# BATHURST QUAY NEIGHBOURHOOD PLAN (BQNP) IMPLEMENTATION

**March 25, 2020**  
**Waterfront Toronto**  
**Design Review Panel:**  
**Design, Construction &**  
**Consultation Update**

Bryan Bowen  
City Planning – Waterfront Secretariat  
March 2020

ARTIST'S RENDERING OF PROPOSED IMPROVEMENTS

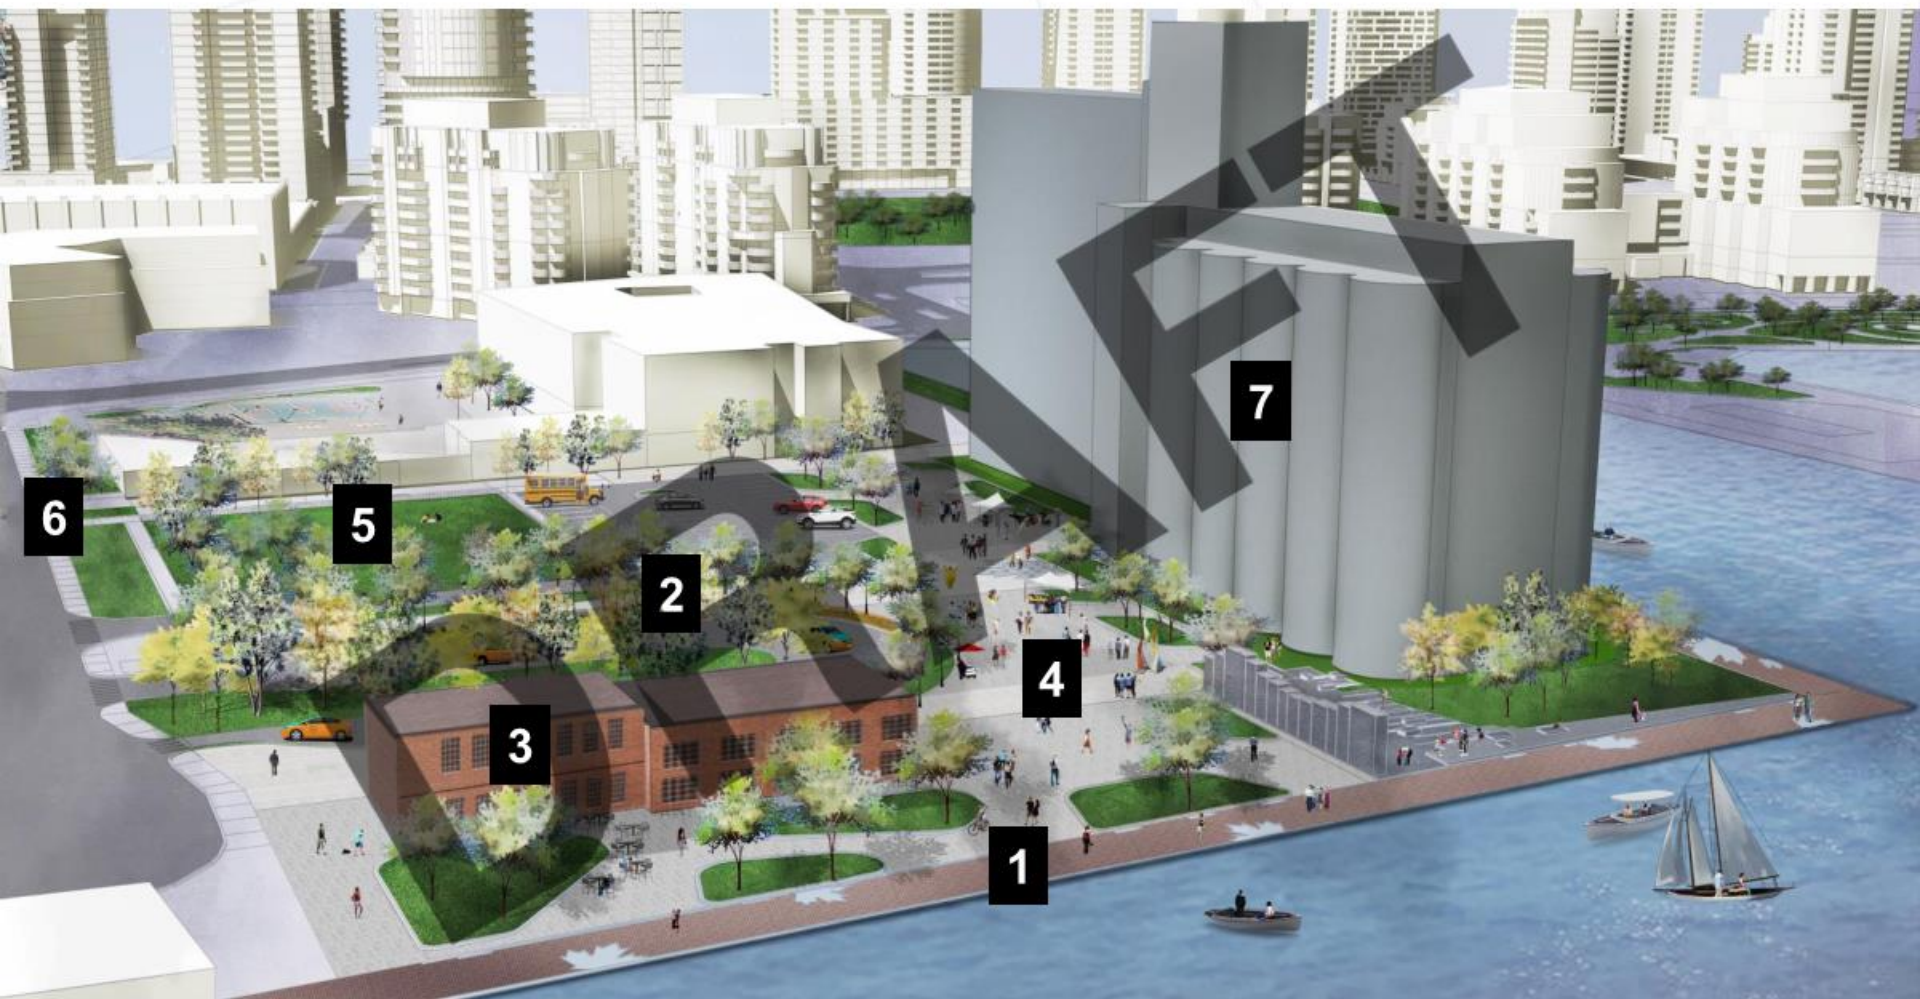
Appreciated the project and thorough explanation of the major moves.

Commended the thoughtfulness of the malting silo revitalization strategy.

The project is an important north-south gateway and will be the first sight of Toronto for many visitors. Encouraged the team to be bold and bring a powerful vision for the project.

Due to the long implementation timeline, it is important for the first moves to be strong to create momentum for remaining work.

Public Realm	Status
Consider a woonerf street typology with table-top pedestrian crossing zones at the parking lot and taxi corral areas.	<i>Revision made.</i>
Consider reducing the amount of hardscape west of the silo and provide more trees and landscape areas.	<i>To be addressed in detailed design phase for plaza.</i>
Provide appropriate rain protection for pedestrians at the taxi corral waiting area.	<i>Revision made.</i>
Explore a range of options with respect to the issue of school play space, including 1): consider engaging the board to swap play-space with parking area; and	<i>Explored in detail. Deemed too great a project risk with negligible net benefits to community users. Additionally offset by 2) below.</i>
2) Consider multi-use strategy for the parking lot and build in flexibility over time.	<i>Revision made. Multi-use strategy covered in this DRP update.</i>
